DC1317A-C ASSY TOP

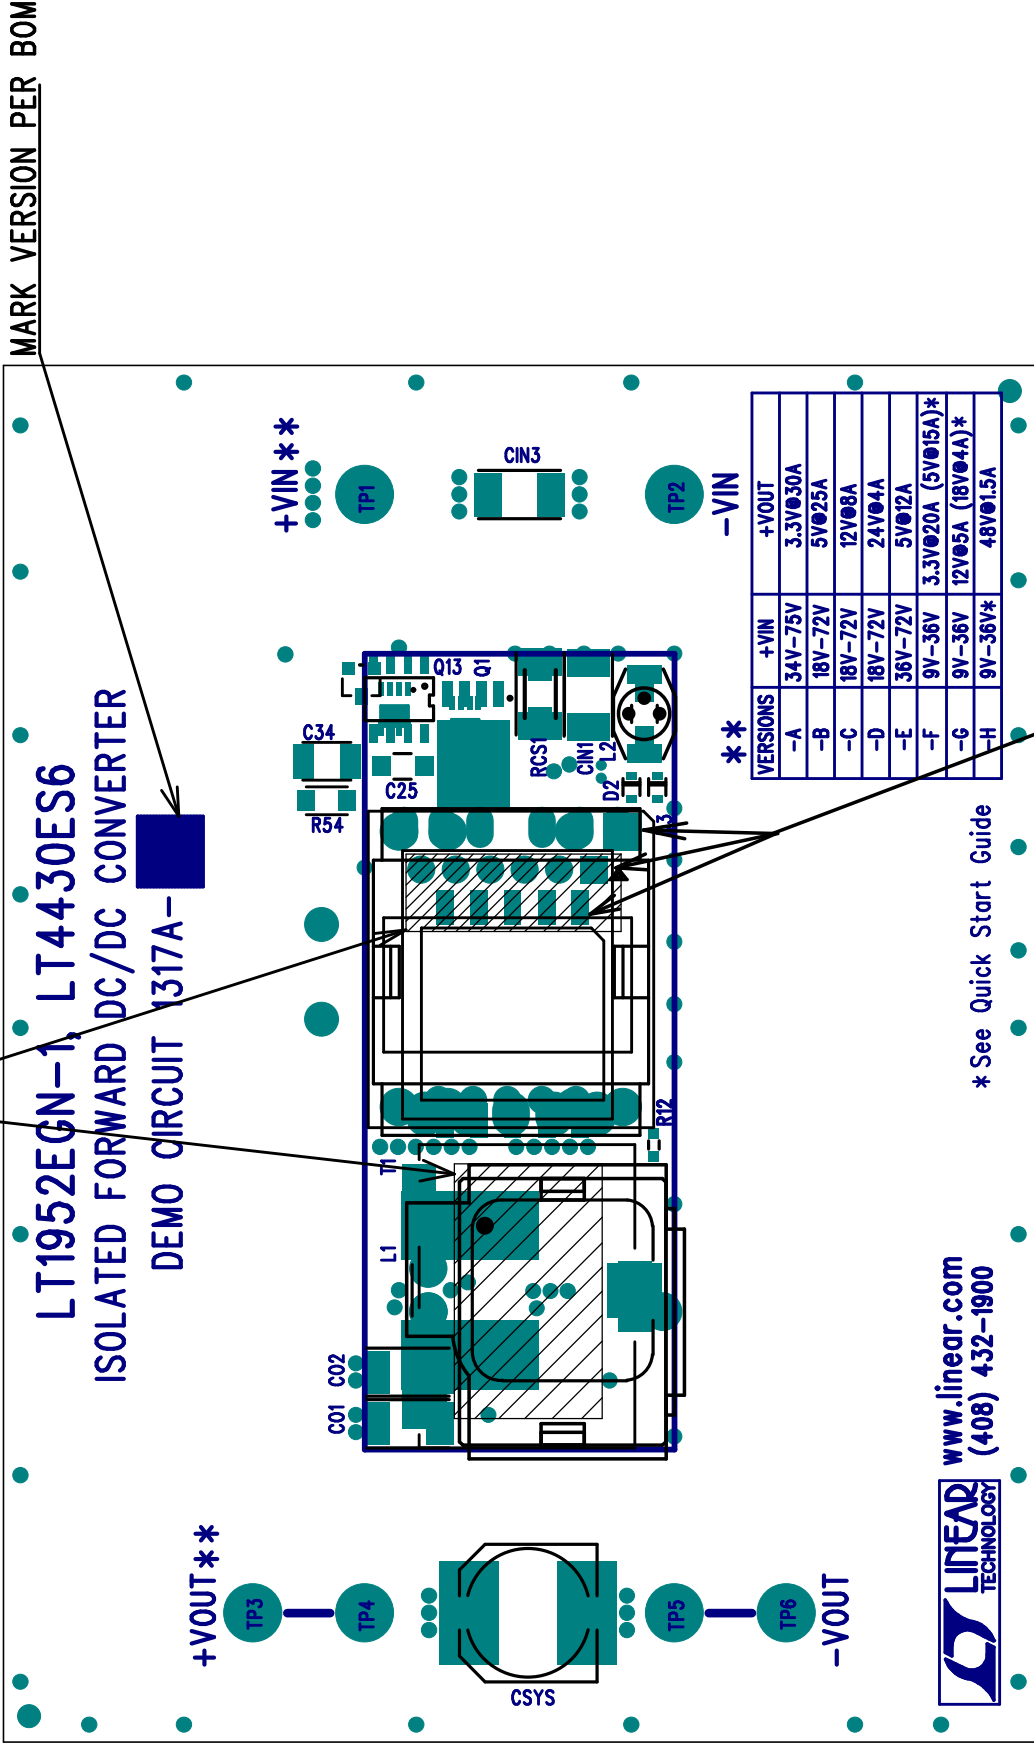
Because of multiple footprint in this design.

Place a piece of kapton tape on board as shown to insulate T1 and L1 from open copper. No solder under kapton tape area (tape off the stencil opening for not used pads under T1 and L1).
